MEMORANDUM

May 7, 2014

TO: Landmarks Board

SUBJECT: Public hearing and consideration of a Landmark Alteration Certificate to remove a c.1922 addition and construct a 1,530 sq. ft. addition at the rear of the house at 835 Pine St. in the Mapleton Hill Historic District, per section 9-11-18 of the Boulder Revised Code (HIS2014-00058).

Figure 14: Proposed North Elevation (rear)

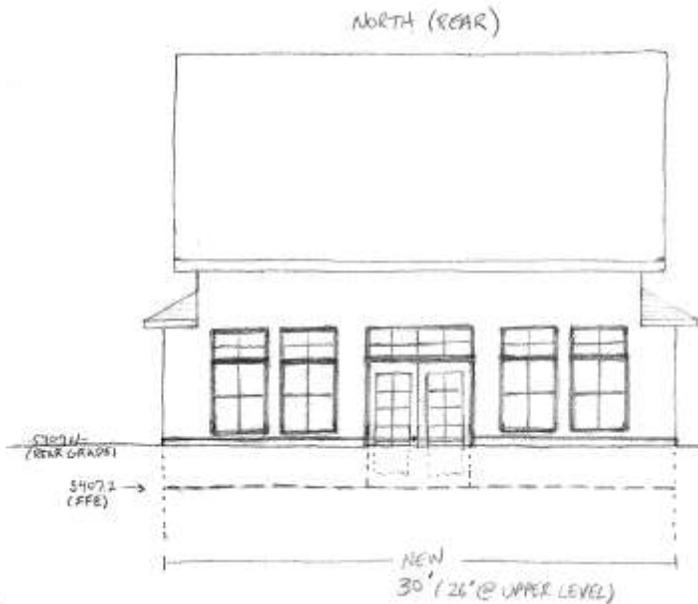
Plans show the north (rear) elevation of the addition to feature a pair of French doors at the center of the rear elevation, with two large divided light windows flanking each side. The lower portion of the north elevation will not be publicly visible due to the sloping grade of the lot. The eaves of the hipped roofs protrude from either side of the north elevation.

.6	<i>Use window shapes that are found on the historic building. Do not introduce odd-shaped windows such as octagonal, triangular, or diamond-shaped</i>	With the exception of the French door/windows on the proposed north elevation, windows are generally in keeping with the historic house.	Yes

Figure 15: Proposed West Elevation

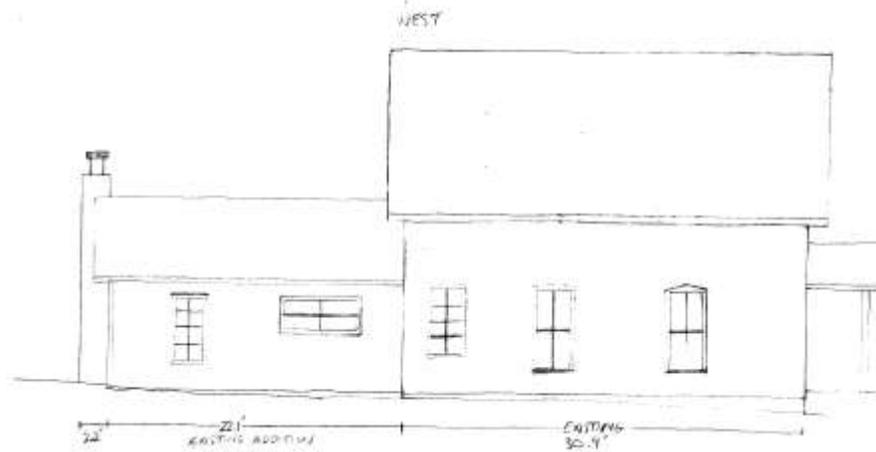
The west elevation features a single, horizontal window on the first level of the connector and a skylight on the connector above. The addition features four divided light windows, with a chimney in the center of the wall.
